**RE: ADDENDUM NO. 2 – DEVELOPMENT OF STAGE 3.1A
ENVIRONMENTAL MANAGEMENT PLAN – SOIL & WATER MANAGEMENT PLAN (MP07_0086)
TOMAGO ROAD, TOMAGO**

ADW Johnson has been engaged by Northbank Enterprise Hub Pty Limited (NEH) to prepare an addendum to the Soil and Water Management Plan (SWMP) completed by ADW Johnson, dated January 2010, for the proposed development being Stage 3 of the approved Part 3A project, Project Approval No. MP07_0086 at Tomago Road, Tomago. Stage 3 comprises the entirety of Lot 210 DP 1174939, however the focus of this addendum to the SWMP is on part of Stage 3 only, named Stage 3.1A.

Previous SWMP correspondence has been reviewed by the Biodiversity & Conservation Division (BCD) forwarded by NSW Department of Planning, Industry & Environment (DPIE) which contained a list of requirements to be addressed for the approval of the Stage 3.1A activities as described below. A checklist is provided in **Section 7** for referencing the responses to the BCD list of requirements.

239944-BEW-103(C)

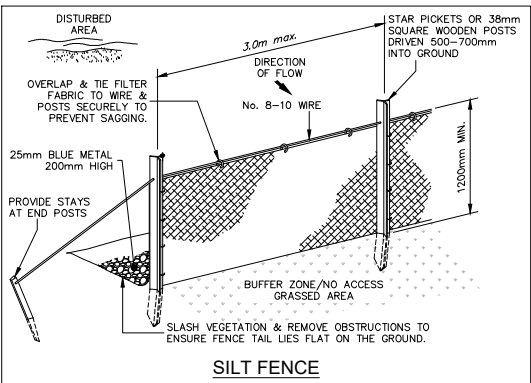
A site inspection was undertaken on the 28th May 2020 by the Principal Engineer from Torque Projects Pty Ltd. Williamtown recorded 73.4 mm of rainfall between 14th-26th May 2020, including 38.8 mm on the 28th May 2020. The rainfall event provided on-ground saturation of existing drains and flow paths observed for the direction of drainage over the typically flat land. Various locations were identified where Lot 210 'leaks' onto Lot 1001 (refer 239944-BEW Sheet 103 for photos). Spoil embankments were consistently dry to walk on, confirming the vegetation zonation and flow directions.

Google Earth imagery dated November 2004 provides the best aerial image defining the existing drainage paths identified during the site visit (refer 239944-BEW Sheet 103 for aerial image). The aerial image also shows that the basin discharges directly into an existing drainage path centralised within Lot 210.
